March 30, 2007

Re: 9701 Brader Way – Baer Insurance SIP

January 17, 2007

SUBJECT: 9701 Brader Way

SHEET NO. **C-0.1**

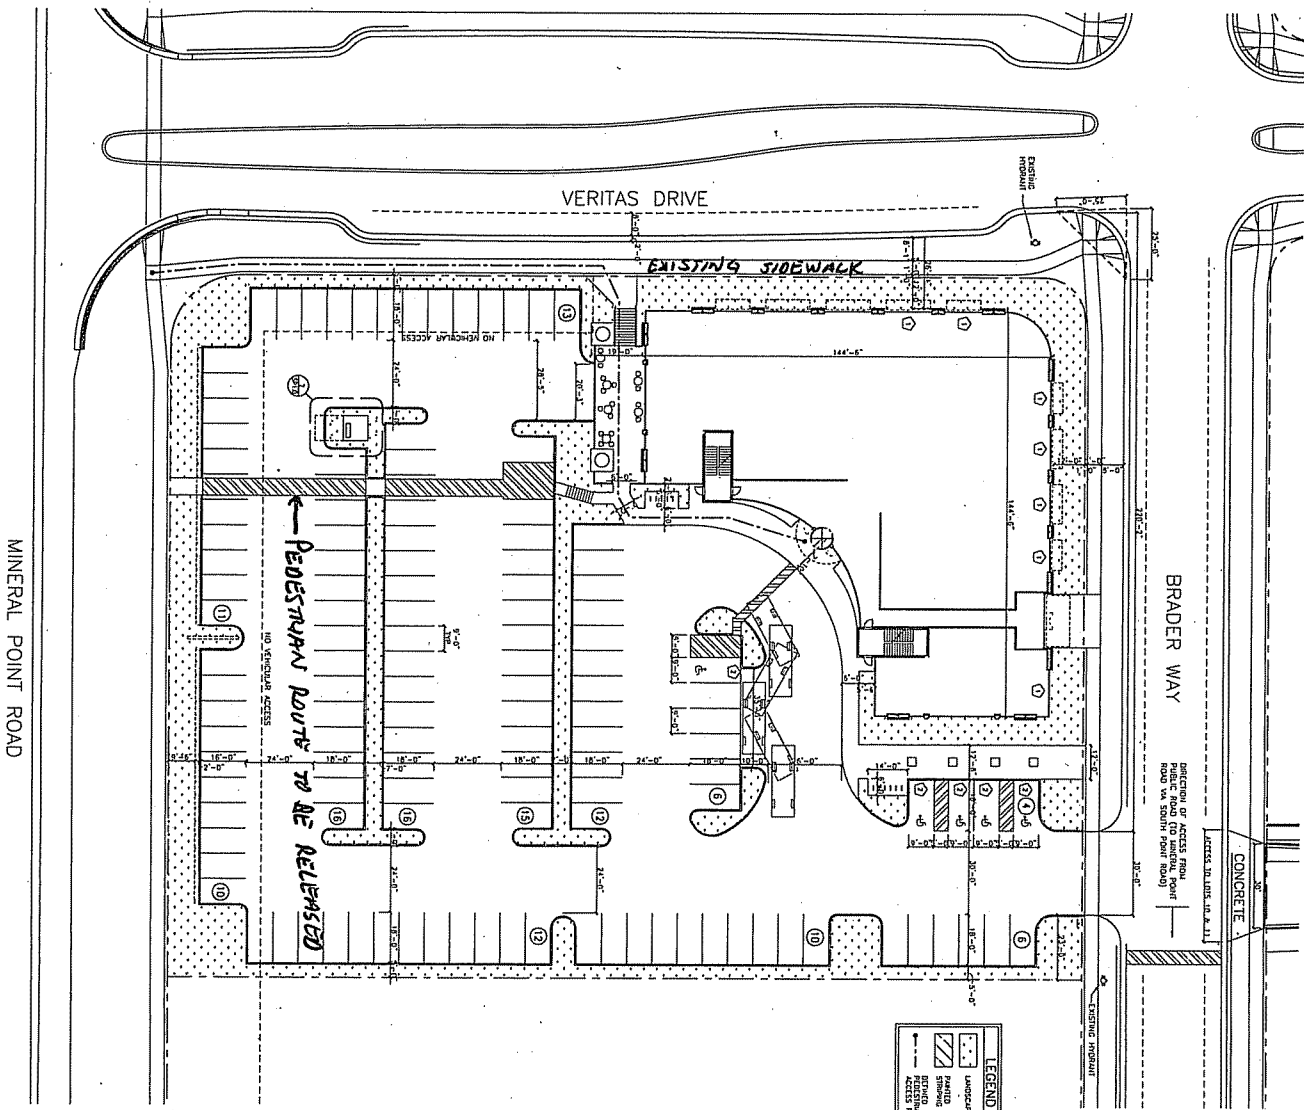
One of the conditions of approval was *“The site plan shall include a defined pedestrian access route connecting the building to Mineral Point Road.”* Arthur Ross was contacted to discuss the location and necessary requirements needed on the site plan to conform with this condition. He has directed us to make the connection from Mineral Point Road to the building directly through the parking lot, see attached plan sheet.

We are respectfully requesting the release of the requirement for the direct connection from Mineral Point Road to the building via the parking lot for the following reasons that we feel are plausible:

- This location is approximately 75-feet from an existing City sidewalk that has a direct connection to the building.
- Pedestrians crossing Mineral Point Road from the south will continue on Veritas Drive sidewalk into the building
- Four valuable parking stalls will be lost
- The anticipated bus route will be through the development via Veritas Drive and Brader Way to the north, both street sidewalks having a direct connection to the building as well.
